Product / Process Change Notification (PCN)	
<input checked="" type="checkbox"/> Major Change <input type="checkbox"/> Minor Change	
PCN Number: PCN_IndLQS_20241106 Affected Series: WE-LQS Affected Order Codes: Please see table below in "Details" PCN Date: 2024-08-06 (YYYY-MM-DD) Effective Date: 2024-11-06 (YYYY-MM-DD)	Change Category: <input type="checkbox"/> Equipment/Location <input checked="" type="checkbox"/> General Data <input type="checkbox"/> Material <input type="checkbox"/> Process <input type="checkbox"/> Product Design <input type="checkbox"/> Shipping/Packaging <input type="checkbox"/> Supplier <input type="checkbox"/> Software
Contact: Product Management Phone: +49 (0) 7942 - 945 5001 Fax: +49 (0) 7942 - 945 5179 E-Mail: pcn.eisos@we-online.com	Datasheet Change: <input checked="" type="checkbox"/> Yes <input type="checkbox"/> No Attachment: <input type="checkbox"/> Yes <input checked="" type="checkbox"/> No

Description of Change: To meet current customer demands, Würth Elektronik eiSos will add a dot on the article surface to show the start of winding (SOW). There will be no change in form, fit, function, quality or reliability of the product. The new revision of th

Marking Change:

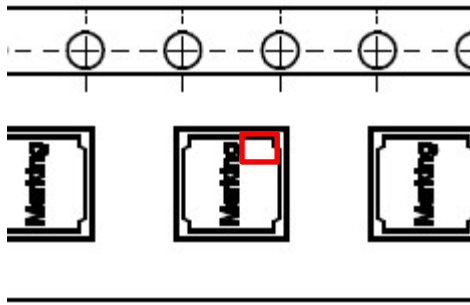
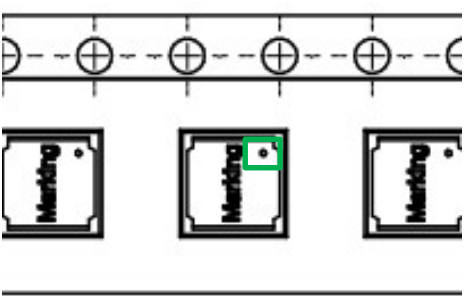
A dot for the start of winding will be added on the article surface to have the opportunity to place the part on the PCB in the best and a reliable way.

Order codes 74404041xxxx and 74404042xxxx		
	Before Change	After Change
Picture: Article Surface		
Picture: Schematic		
Picture: Article Orientation in reel
